Access Compliance Report

Public Rights-of-Way

(Curb Ramps)

Intersection ID: 47272	Main Street: LEAHURST_CT	Cross Street: LIDDINGTON_RD	Location: SE
ADA ID: E4024F6212F0	Ramp Type: PerpDiag	Initial Pass/Fail: Fail	Overall Compliance: No
Severity Score: 8.75			
Codes/Mitigation Info/Possible Solution		Field Measurements/Component Compliance

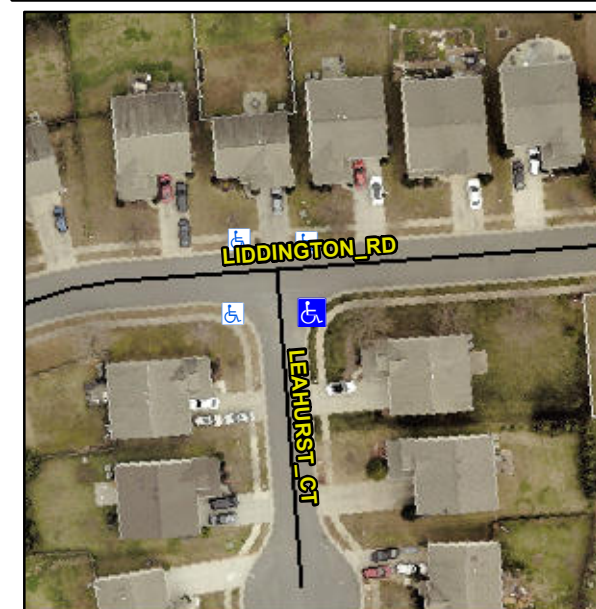
Not Found, R304.5.1

Compliance	Description	Data	Compliance	Description	Data
N/A	Ramp Length (in)	49.0	Yes	Ramp Slope (%)	6.3
No	Ramp Width (in)	43.0	Yes	Ramp XSlope (%)	1.5
N/A	Flare Type LT	N/A	N/A	Flare Type RT	N/A
N/A	Flare Slope LT (%)	N/A	N/A	Flare Slope RT (%)	N/A
N/A	Flare Traversable LT?	N/A	N/A	Flare Traversable RT?	N/A
N/A	Landing Length (in)	N/A	N/A	DWS Provided?	N/A
N/A	Landing Width (in)	N/A	N/A	DWS Contrast?	N/A
N/A	Landing Slope (%)	N/A	N/A	DWS Length (in)	N/A
N/A	Landing X Slope (%)	N/A	N/A	DWS Full Width?	N/A
N/A	Landing Curb? (Y/N)	N/A	N/A	DWS Offset (in)	N/A
N/A	Shared Landing?	N/A			
N/A	Gutter Ponding?	N/A	N/A	Gutter Slope (%)	N/A
N/A	Gutter Lip Ht (in)	N/A	N/A	Gutter X Slope (%)	N/A
N/A	Painted X Walk1?	No	N/A	Painted X Walk2?	No
	X Walk 1 Direction	To N		X Walk 2 Direction	To W
N/A	X Walk 1 Width (in)	N/A	N/A	X Walk 2 Width (in)	N/A
	X Walk 1 Slope (%)	2.3		X Walk 2 Slope (%)	1.5
	X Walk 1 X Slope (%)	1.2		X Walk 2 X Slope (%)	1.6

Remove & Replace Curb Ramp With Two New Directional Ramps or Equivalent.
